**LOCAL REVIEW BODY
TOWN & COUNTRY PLANNING (Schemes of Delegation and Local Review
Procedure) (SCOTLAND) REGULATION 2013.**

CROFT 3, CASTLETON, LOCHGILPHEAD ARGYLL

REQUEST FOR FURTHER INFORMATION BY WRITTEN SUBMISSIONS

Definition of "X" and "Y" Distances

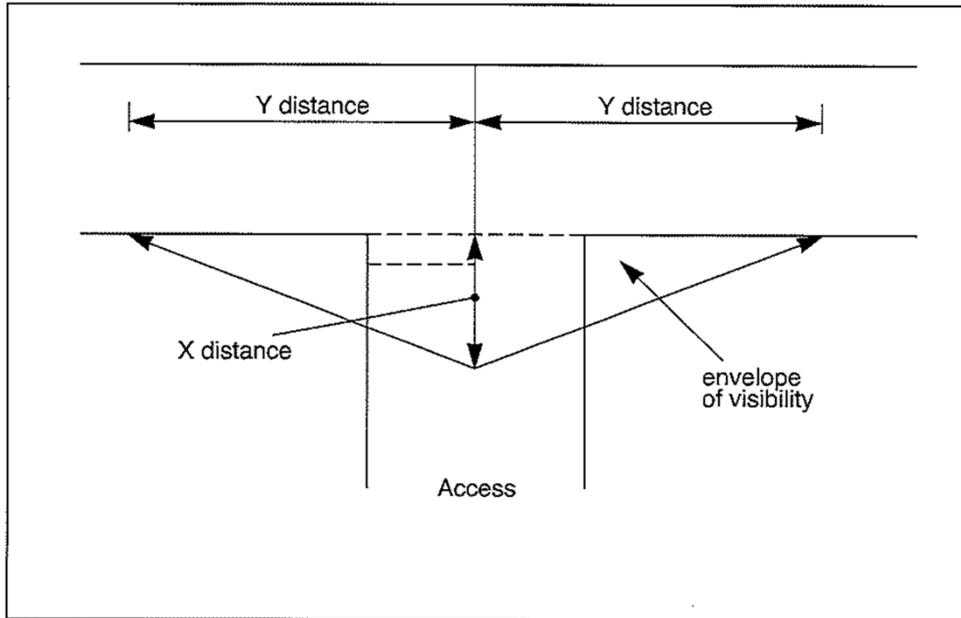
The visibility splays are the triangles of ground bounded on 2 sides by the first 4.5 metres of the centreline of the access road (the set back dimension) and the nearside trunk road carriageway measured 215 metres (the y dimension) in both directions from the intersection of the access with the trunk road. In a vertical plane, nothing shall obscure visibility measured from a driver's eye height of between 1.05 metres and 2.00 metres positioned at the set back dimension to an object height of between 0.26 metres and 1.05 metres anywhere along the y dimension.

The above definition of how the visibility splay should be measured and the required set back dimensions 'x' and 'y' are taken from the Design Manual for Roads and Bridges, Volume 6, Section 2, Chapter 2, Part 7 TD 41/95 'Geometric Standards for Direct Access', Paragraph 2.15 to 2.26.

The visibility splay envelope is the area of ground contained within the triangle of ground formed by the measurements above and illustrated in the above diagram.

APPENDIX A

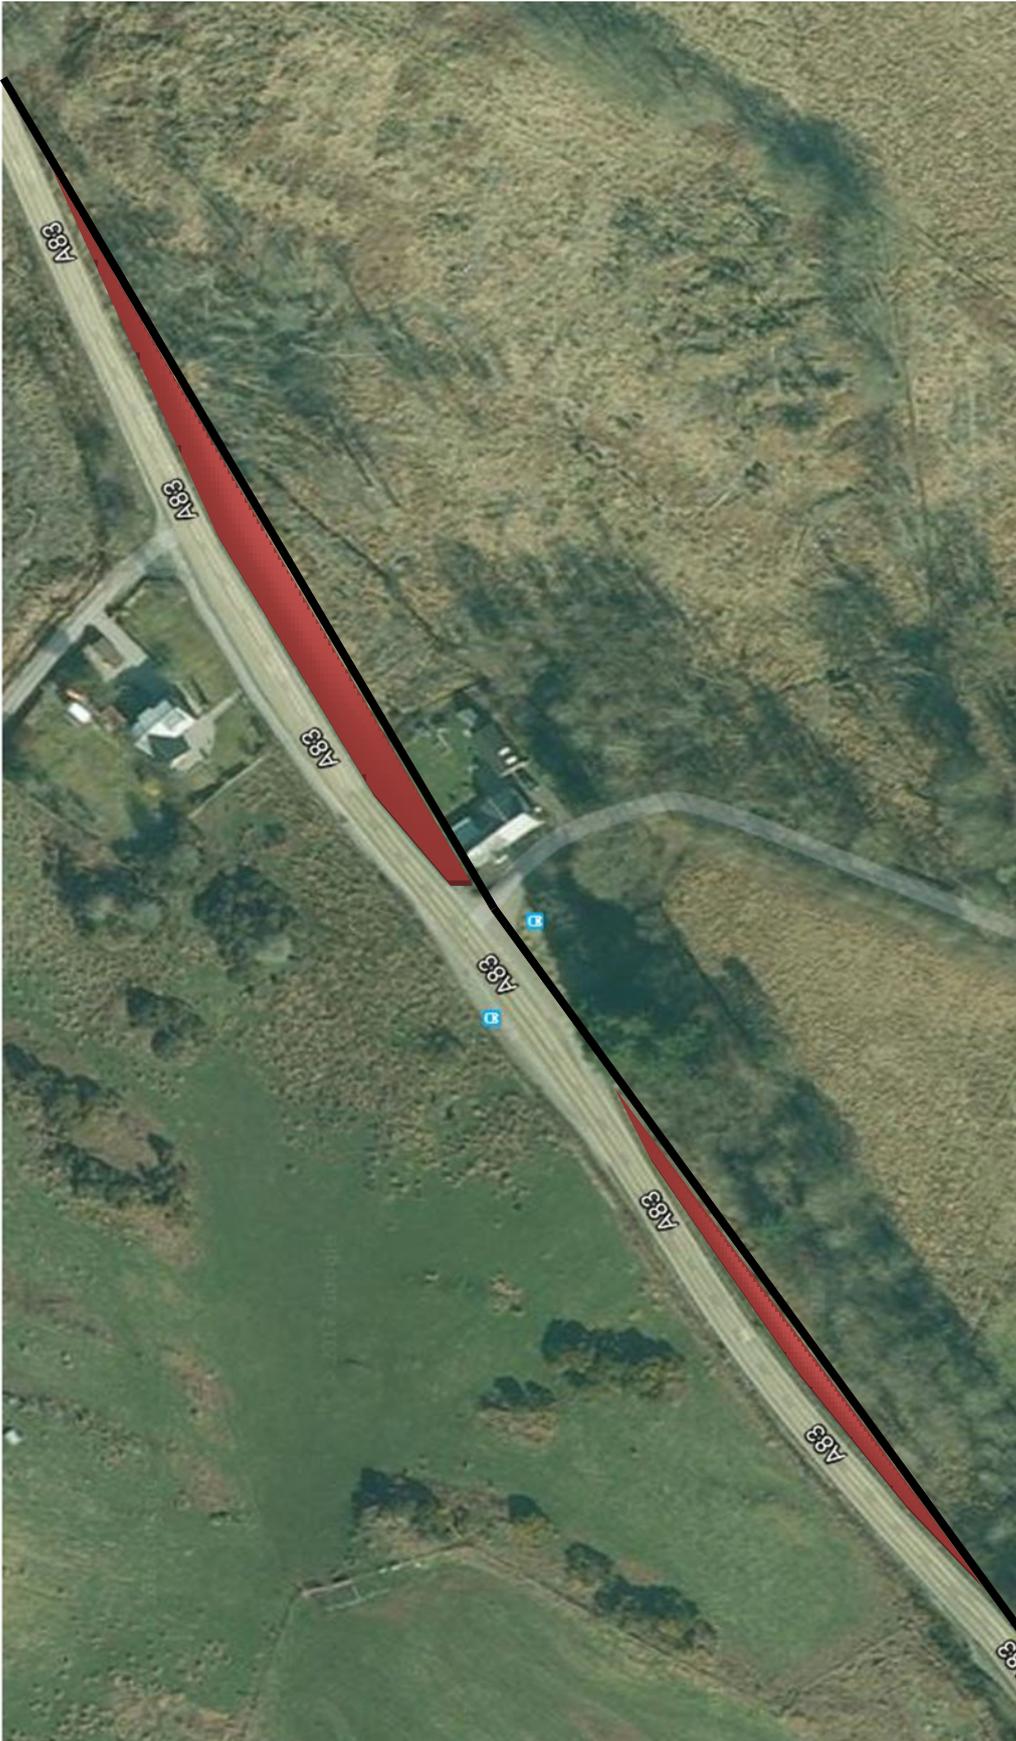
Access 1 - Westerly access

Actual Visibility	120 m to left	188 m to right
Achievable Visibility	215 m to left	190 m to right

Access 2 - Easterly access

Actual Visibility	134 m to left	9.0 m to right
Achievable Visibility	215 m to left	215 m to right

Whilst the achievable visibility meets current design standards and notwithstanding the applicants requirement to control the land within the visibility splay envelope there may also be physical works required. The scope of these works could extend to general ground clearance and in more extreme cases earthworks. The Maps in Appendix A illustrates the extent of the land outwith the Trunk Road boundary which would require the applicant to gain control over, shaded red.

When considering this planning application Transport Scotland originally responded recommending conditional acceptance as it was apparent that the visibility splays were achievable, response dated 22 August 2013. The condition required the applicant to provide evidence to the satisfaction of Argyll and Bute Council that they could provide and maintain the required visibility splays in perpetuity. However Transport Scotland were advised the applicant could not gain control of the land within the visibility splay envelope that was outwith the Trunk Road boundary accordingly Transport Scotland revised the original recommendation to refusal, response dated 27 August 2013.
